# SVD Geometry Implementation

Update to rev. 2.2

# Sensors

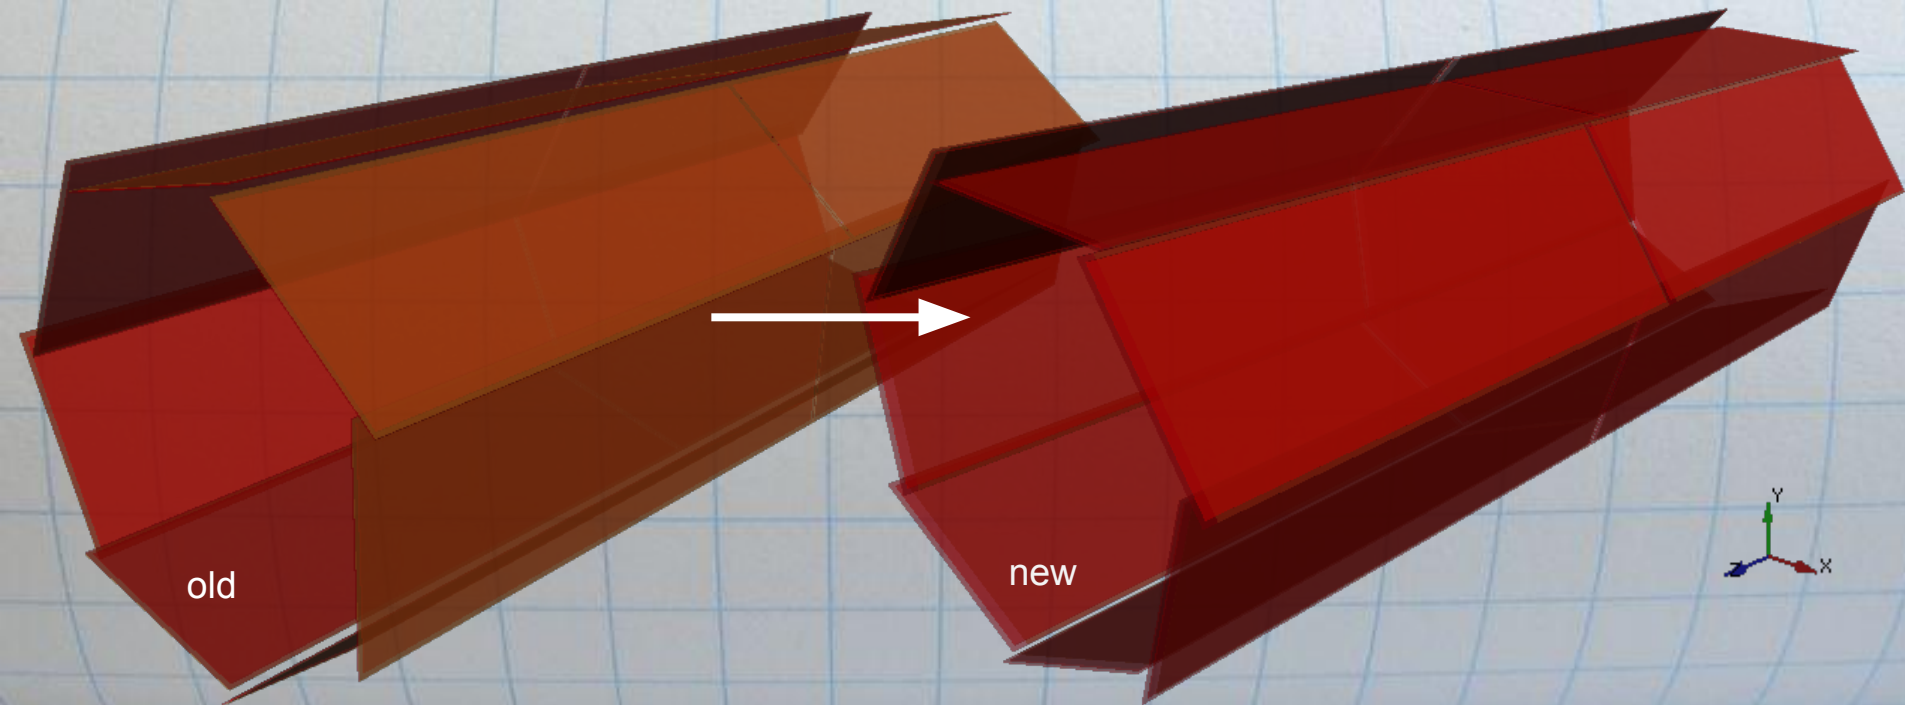
- ✓ Ladders positions (rotated & shifted)
- ✓ Sensor positions (shifted)
- ✓ Layer 3 sensors (resized & kapton moved to the bottom)

$\phi = 15^\circ$ ; shift = 0.686 mm; radius += 0.17 mm; DSSD length += 4.86 mm;

# Cooling Pipes

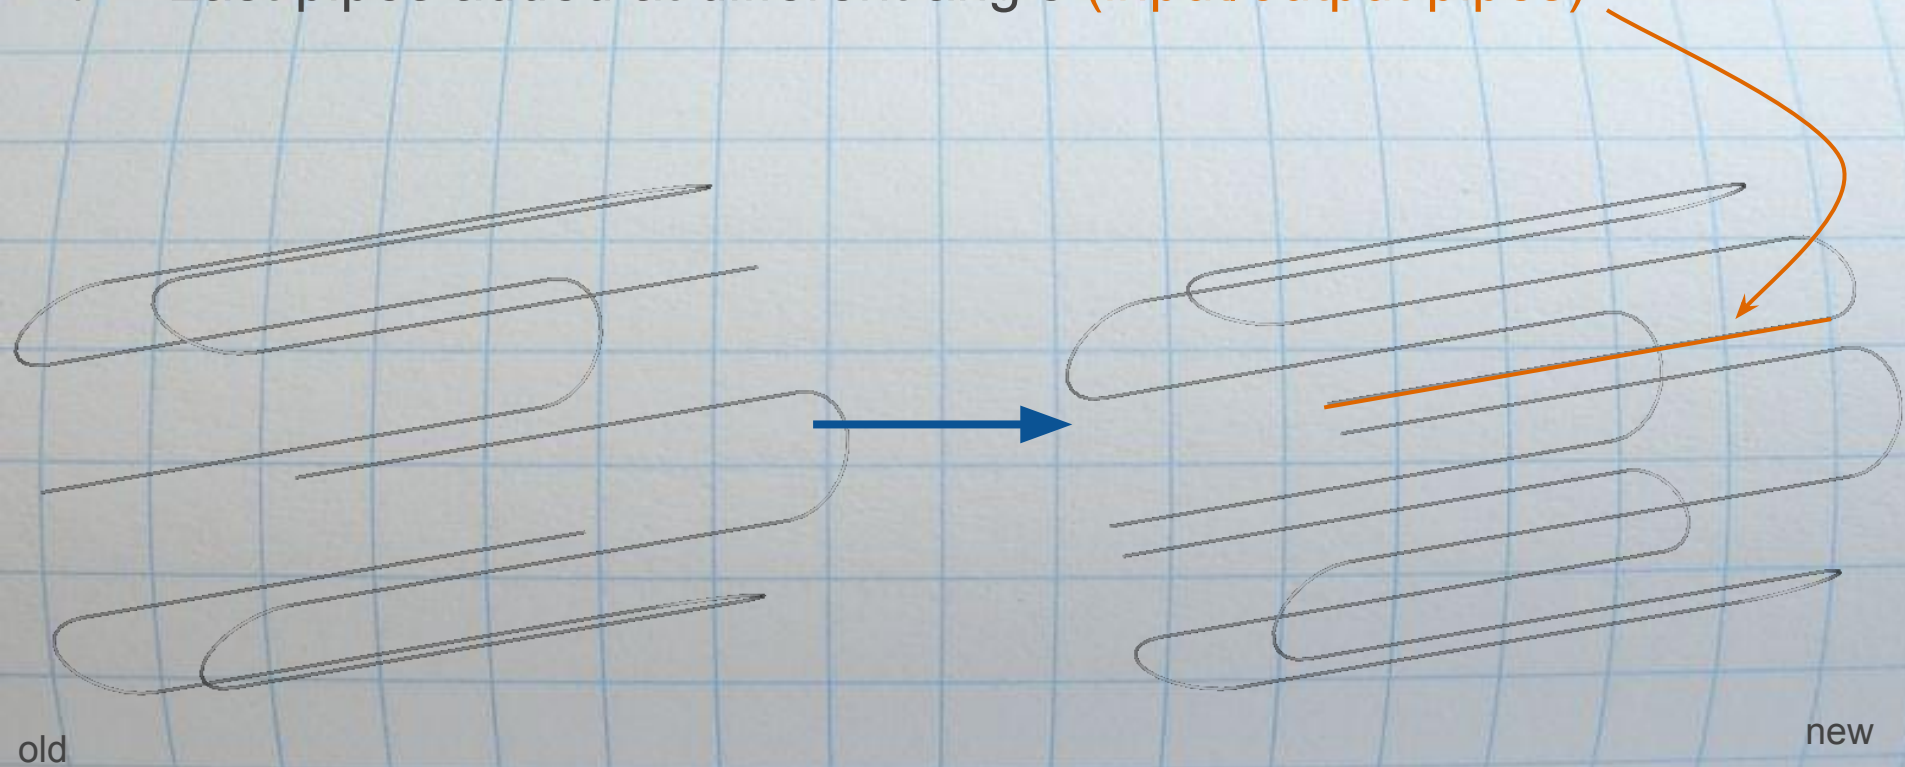
- ✓ Rotated along with ladders
- ✓ Last pipes added at different angle (input/output pipes)

# Support

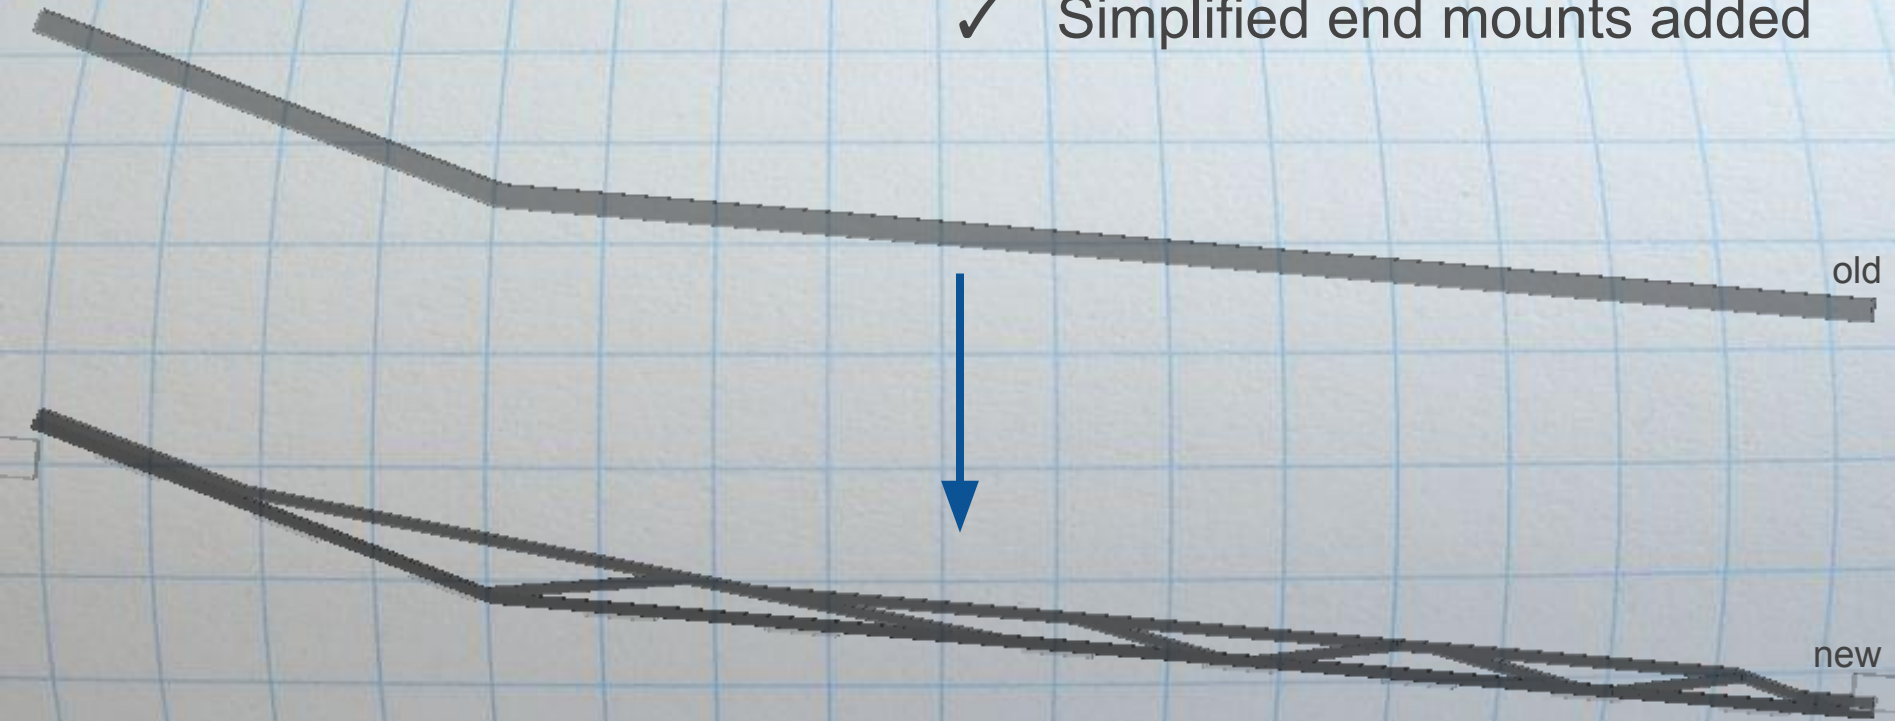
- ✓ Ribs adjusted, tabs added
- ✓ End rings thickness updated
- ✓ Simplified end mounts added

# Support

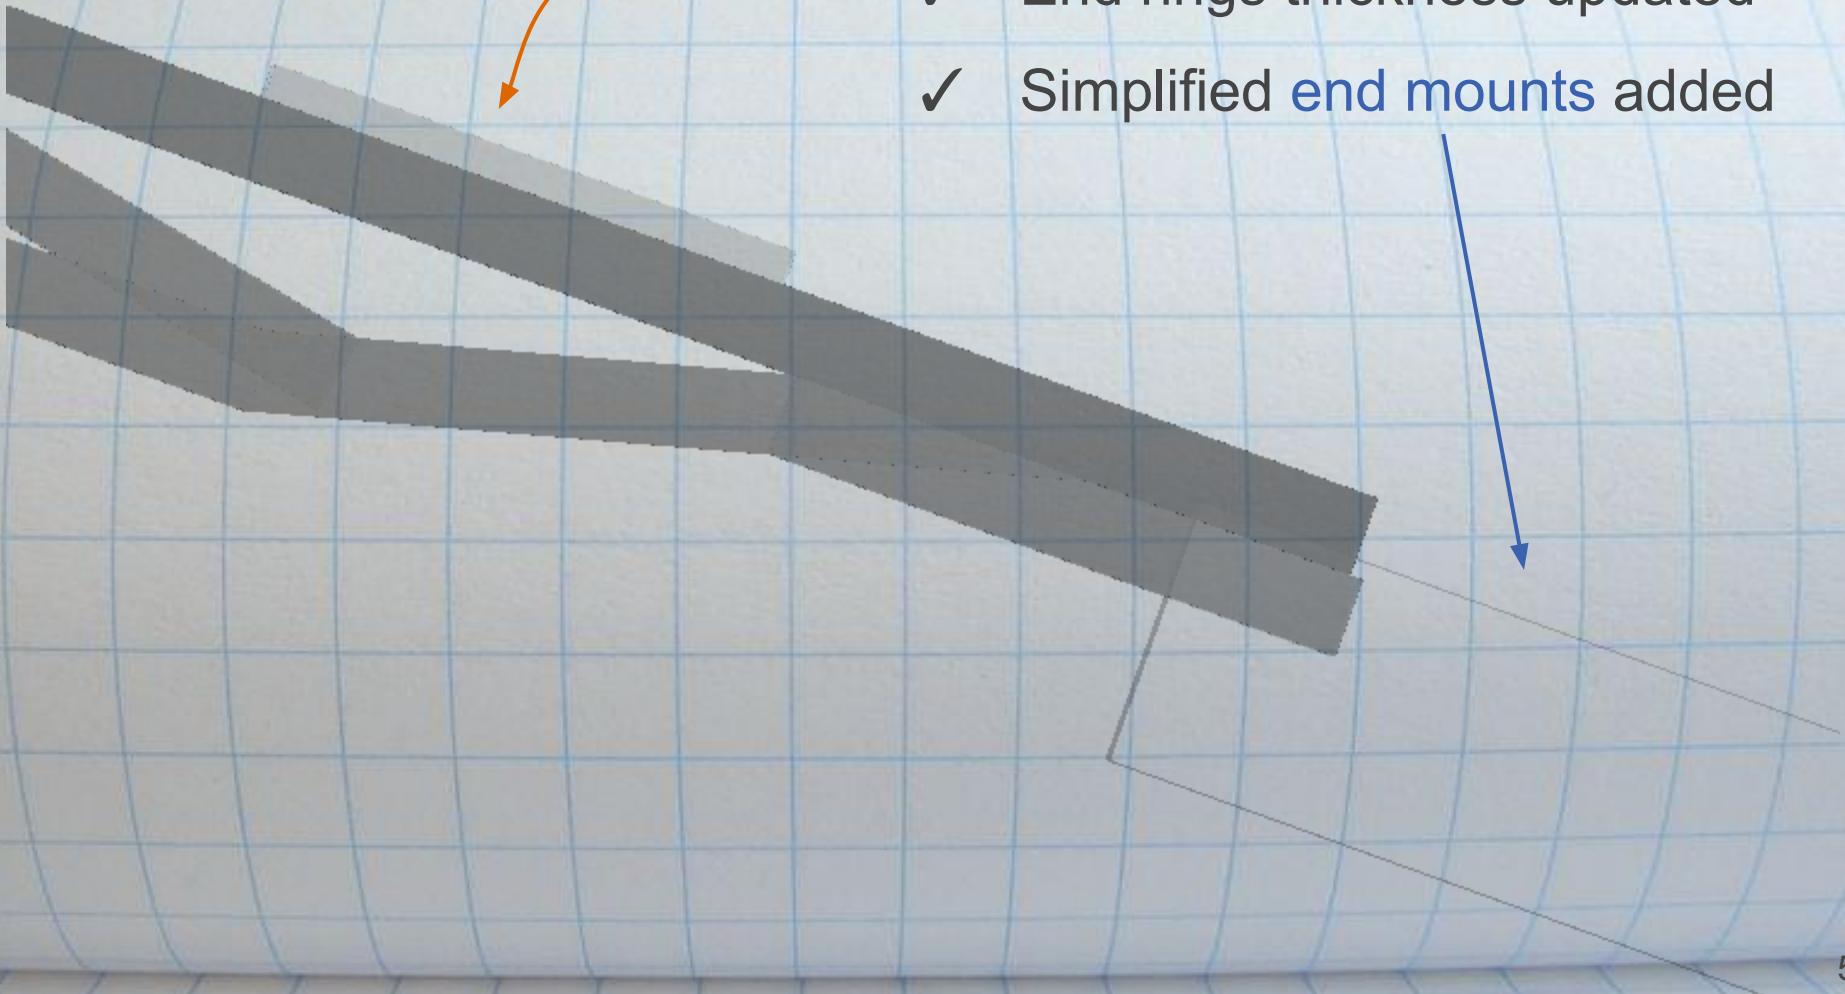
- ✓ Ribs adjusted, **tabs** added
- ✓ End rings thickness updated
- ✓ Simplified **end mounts** added
